**FINAL DRAINAGE REPORT ADDENDUM #1
FOR
PLATTE SELF STORAGE
COLORADO SPRINGS, COLORADO**

JUNE 2025

TNE Job No. 2419.00
County Job No. PPR2418

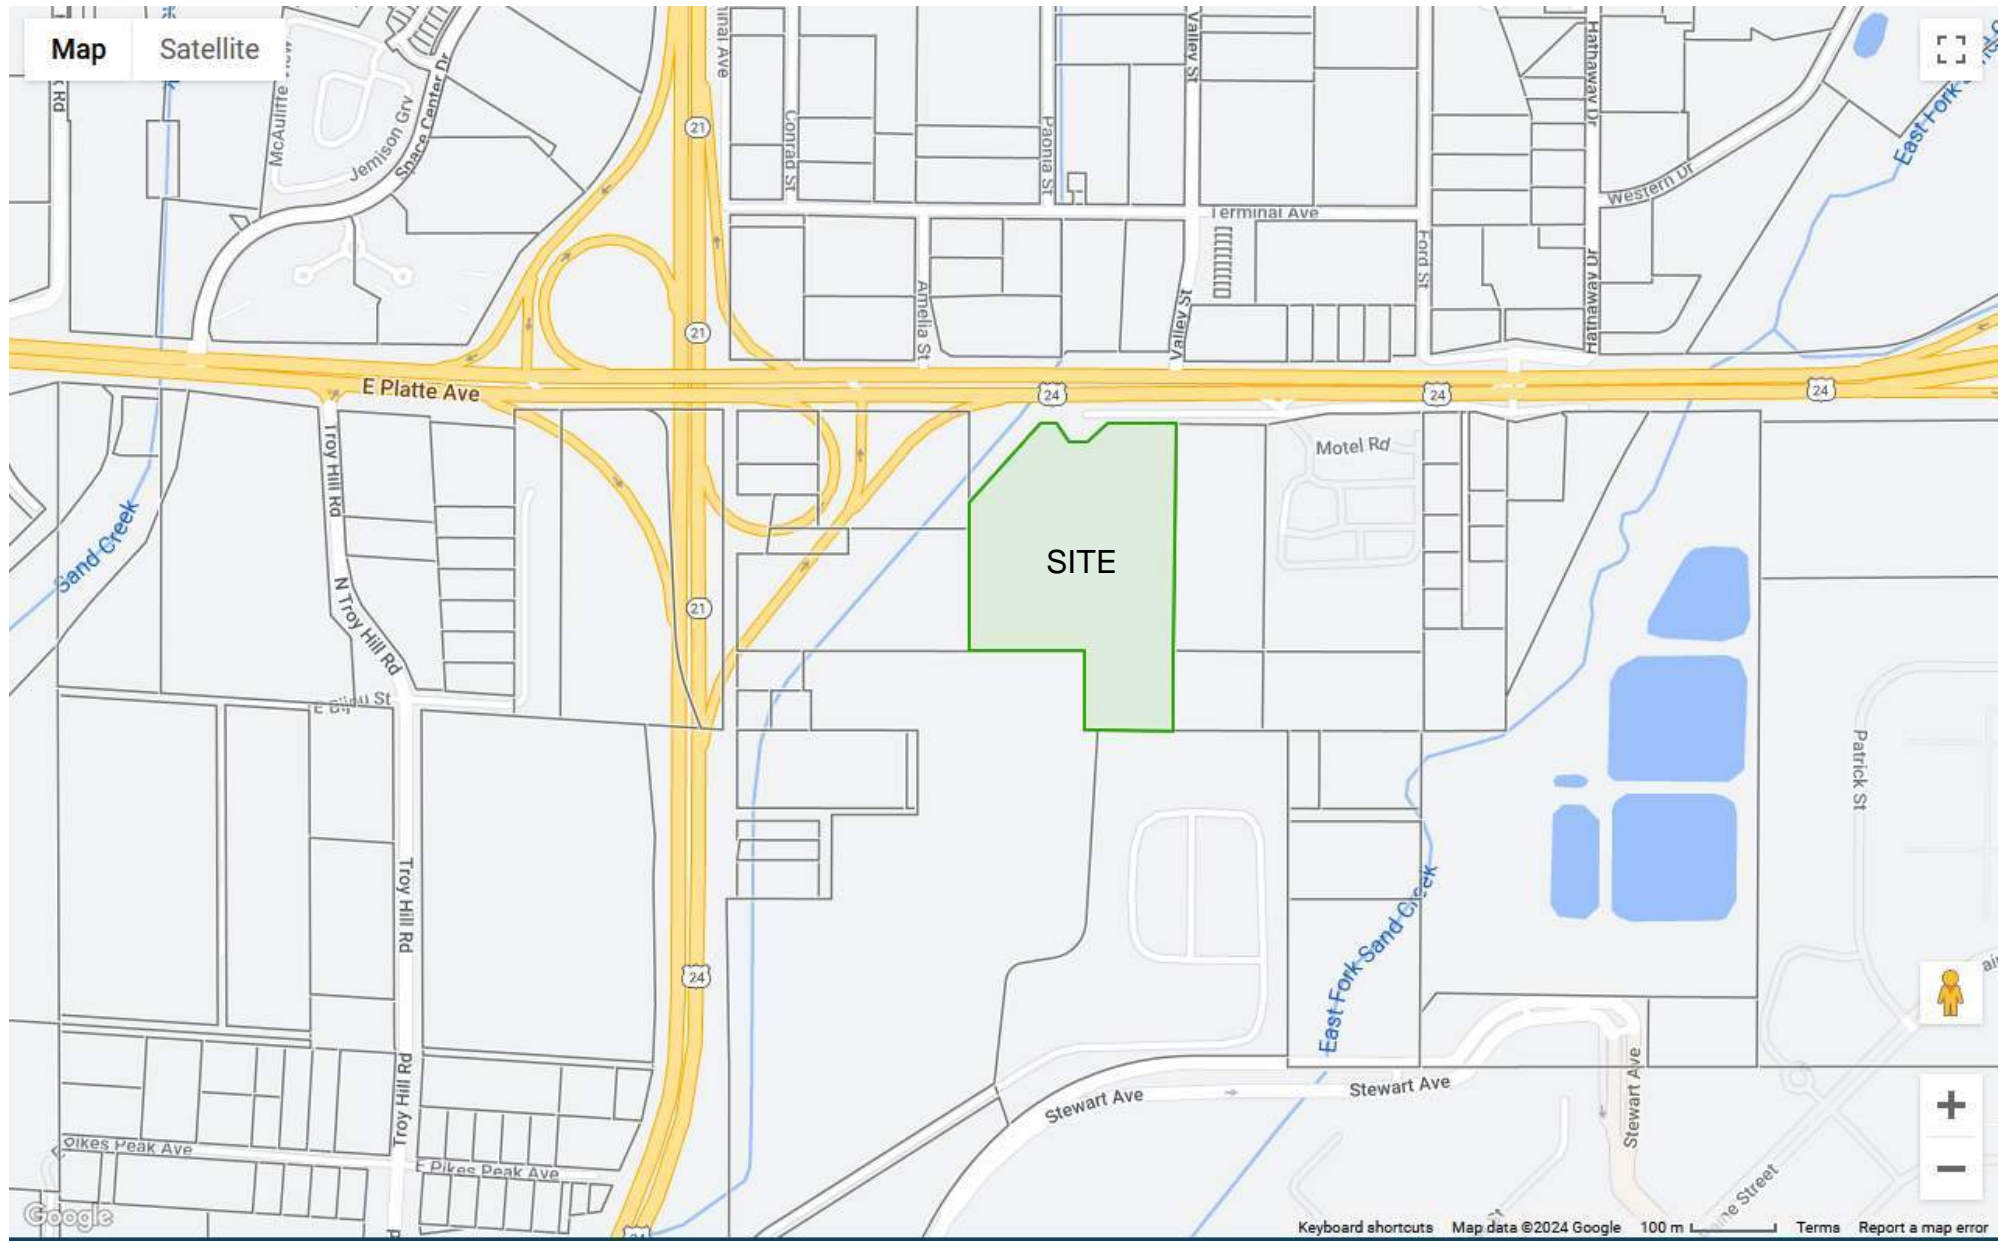
Unresolved:
Include a statement regarding the pond: changes, minor changes, no changes. Works exactly the same or have there been minor changes to outfall/release data?

Unresolved:
Any changes to estimate?
